TRAFFIC ENGINEERING AND OPERATIONS BULLETIN 17-01
ROADWAY DESIGN BULLETIN 17-01
(FHWA Approved: January 6, 2017)

SUBJECT: Design Standards Index 17727 – Span Wire Traffic Signal Hangers

The following two **Design Standards Revisions (DSR)** are released:
Revised FY 2016-17 Index 17727, (Signal Cable & Span Wire Installation Details); and
Revised FY 2017-18 Index 17727, (Signal Cable & Span Wire Installation Details).

INDEX NO.
17727

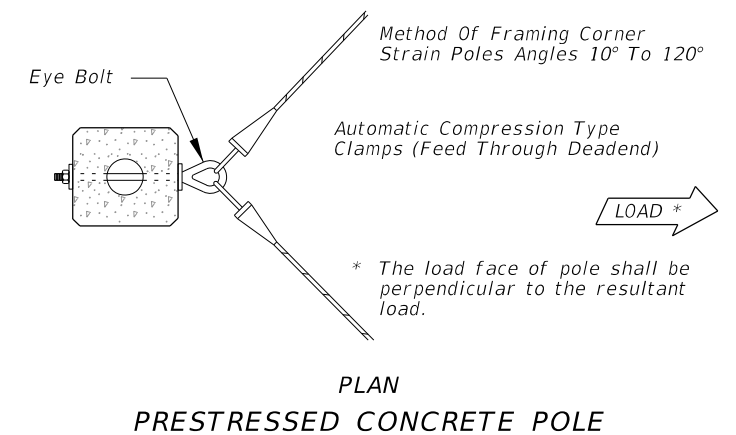
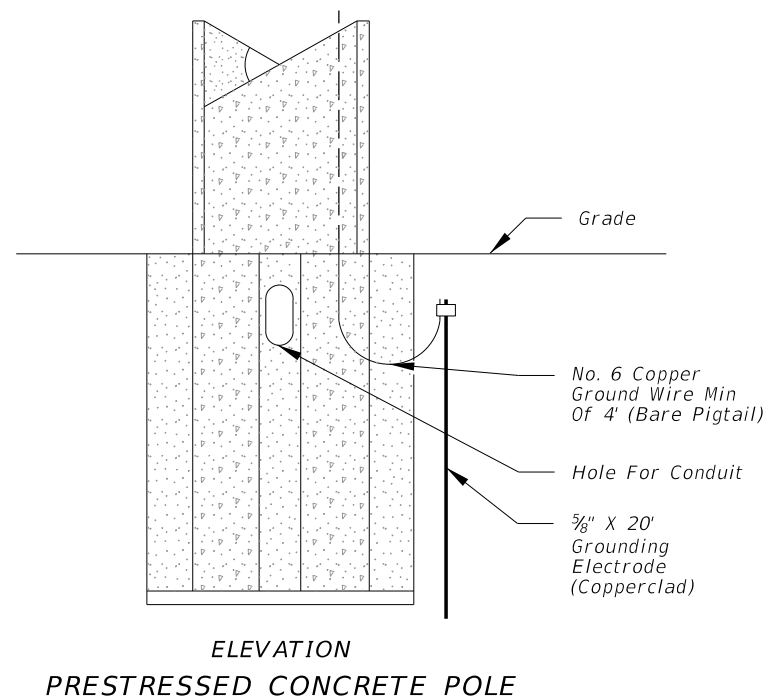
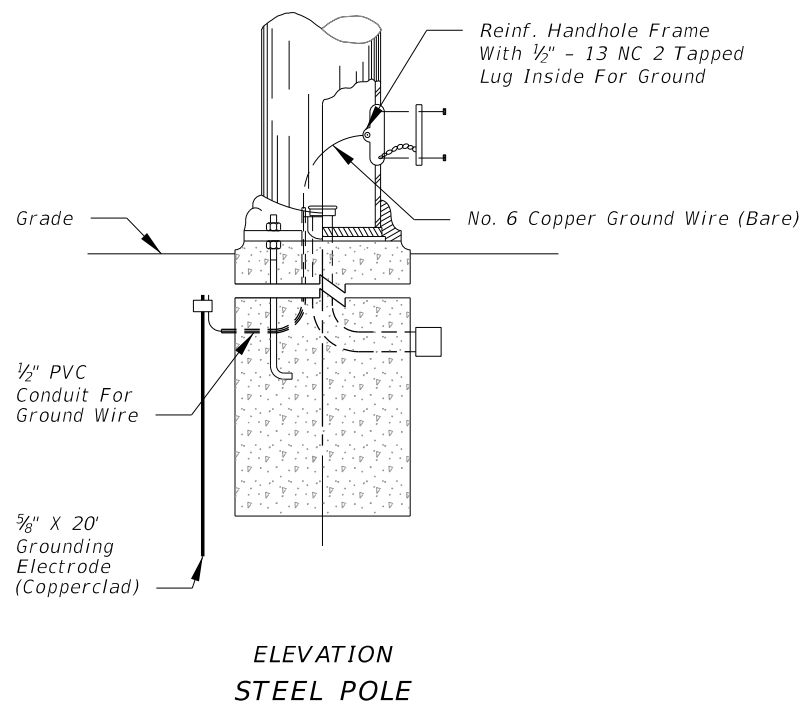
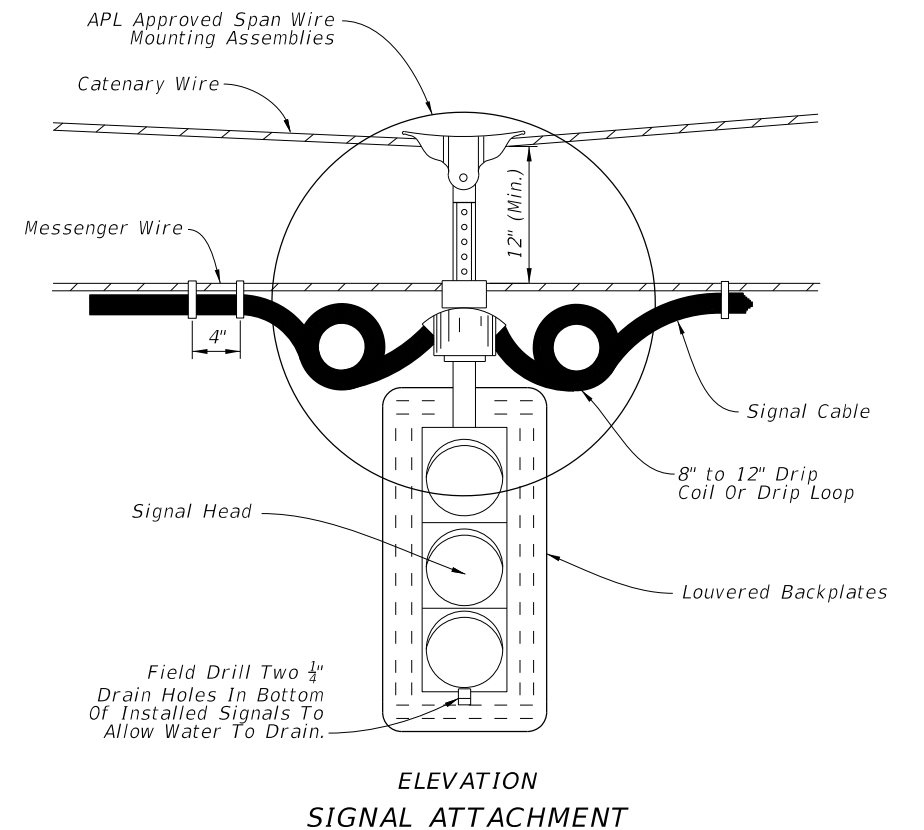
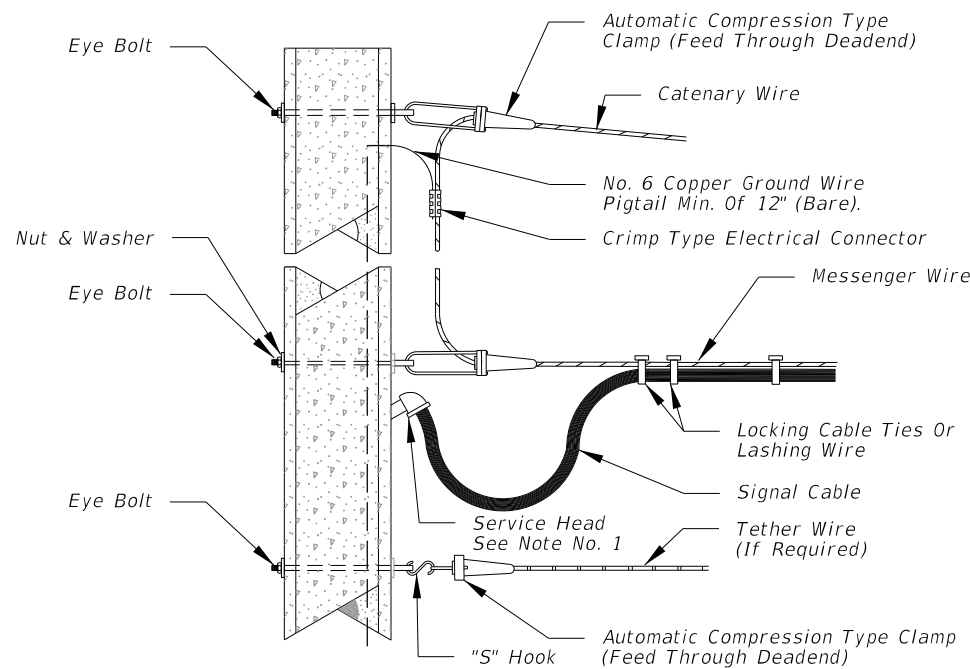
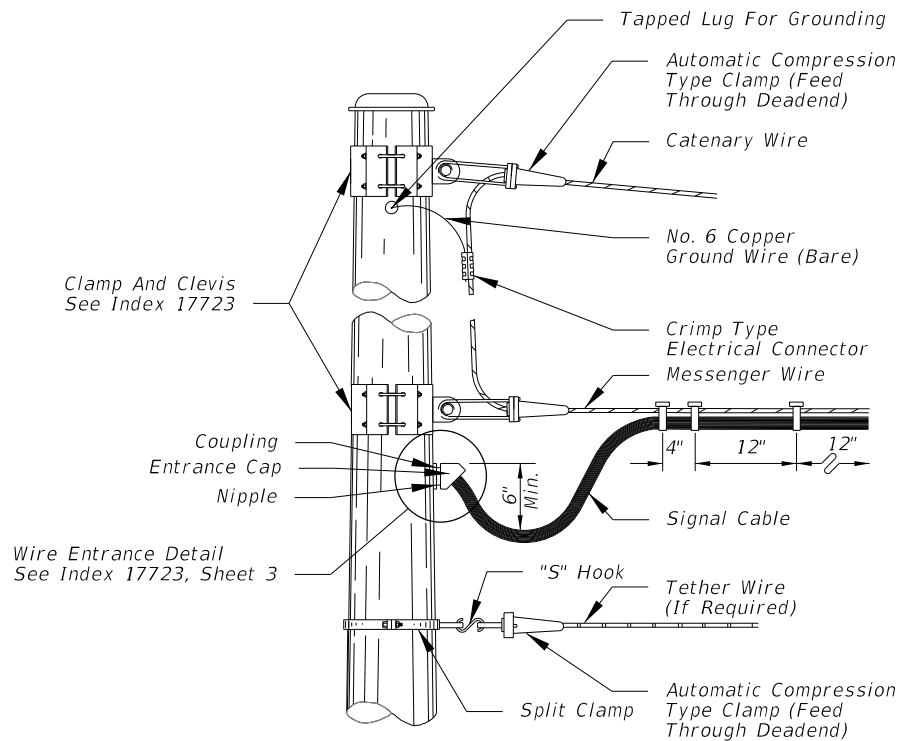
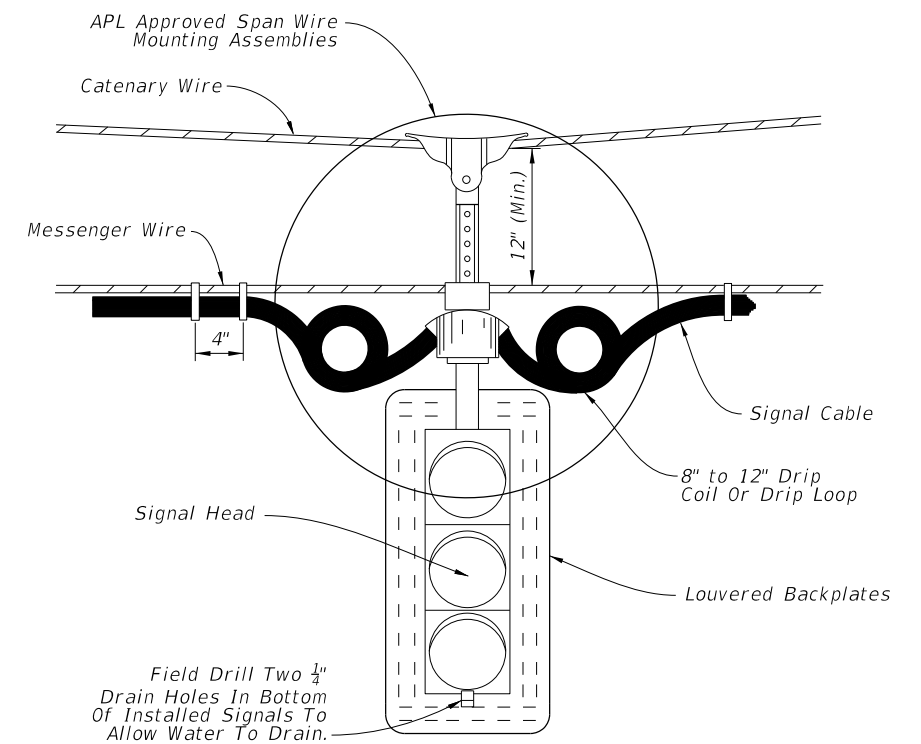
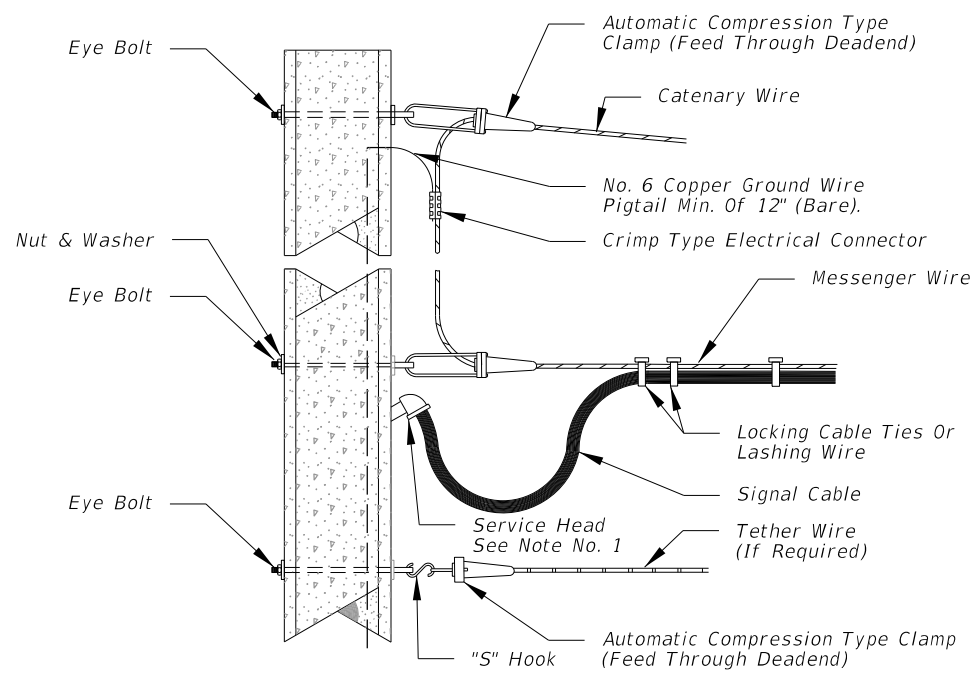
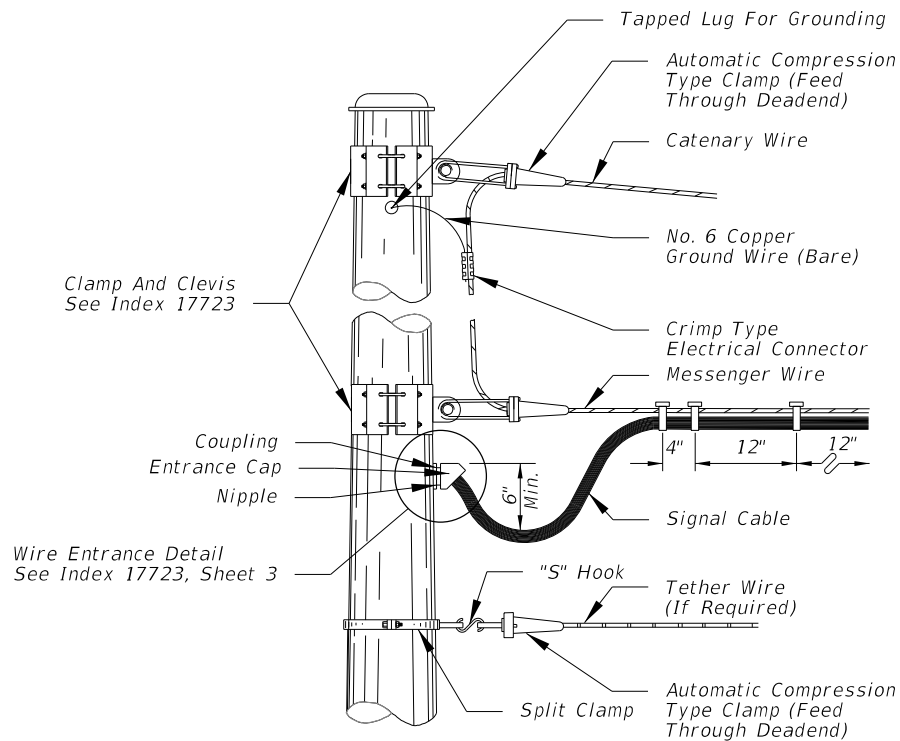
The Department is changing the Design Standard for span wire traffic signal hangers to allow any Adjustable Signal Hanger listed on the Department's Approved Product List (APL). Currently, the adjustable signal hangers on the APL are the Tri-Stud Adjustable Hanger Assembly and the Pivotal Adjustable Hanger Assembly (PAHA). **Design Standards**, Index 17727 (Signal Cable & Span Wire Installation Details) has been reissued as a **DSR**.

LAST REVISION 01/05/17	REVISION	DESCRIPTION: Sheet 1: Added Note #1; Moved SIGNAL ATTACHMENT details from Sheet 2. Sheet 2: Deleted Sheet.
---------------------------	----------	--

1. Use only span wire mounting assemblies listed on the APL. For specific details and requirements, see the vender drawings on the APL.
2. With the approval of the resident engineer, the service head hole for joint use poles may be drilled by the utility company at an angle of 90° but not less than 45° to the face of the pole.
3. Lashing wire should normally be used for distances of 12' or greater.
4. All hardware for signal attachment shall be stainless steel.
5. Hole for eye bolt will require field reaming for 1" & 1 1/4" eye bolts.
6. Meet all grounding requirements of Specification 620.

INDEX NO. 17727	SHEET NO. 1 of 1
---------------------------	----------------------------

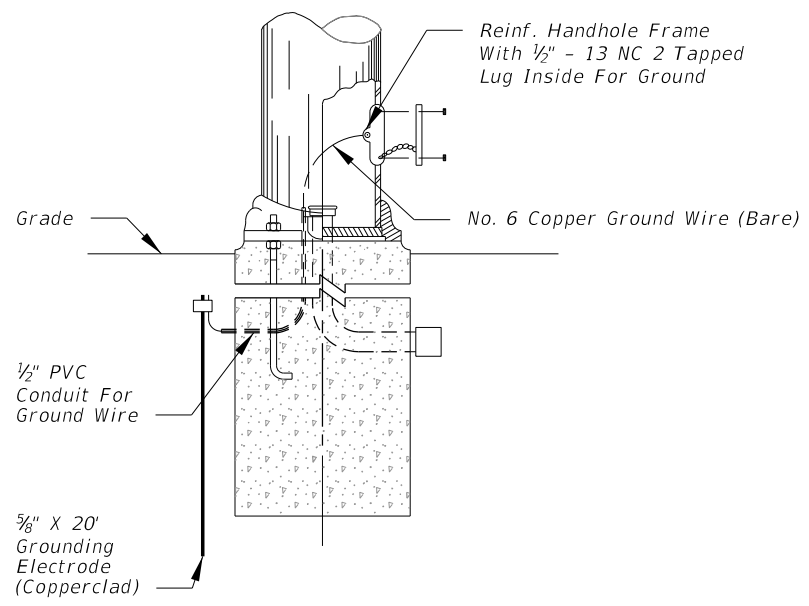
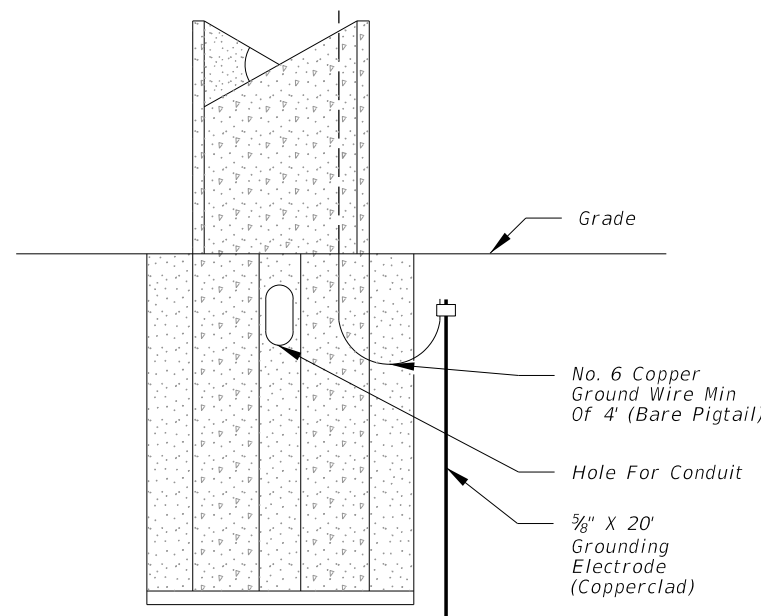
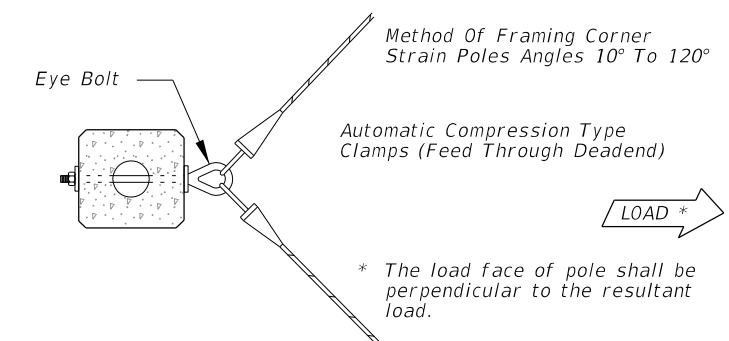
LAST REVISION 01/05/17	DESCRIPTION: Sheet 1: Added Note #1; Moved SIGNAL ATTACHMENT details from Sheet 2. Sheet 2: Deleted Sheet.
---------------------------	--

1. Use only span wire mounting assemblies listed on the APL. For specific details and requirements, see the vendor drawings on the APL.
2. With the approval of the resident engineer, the service head hole for joint use poles may be drilled by the utility company at an angle of 90° but not less than 45° to the face of the pole.
3. Lashing wire should normally be used for distances of 12' or greater.
4. All hardware for signal attachment shall be stainless steel.
5. Hole for eye bolt will require field reaming for 1" & 1 1/4" eye bolts.
6. Meet all grounding requirements of Specification 620.
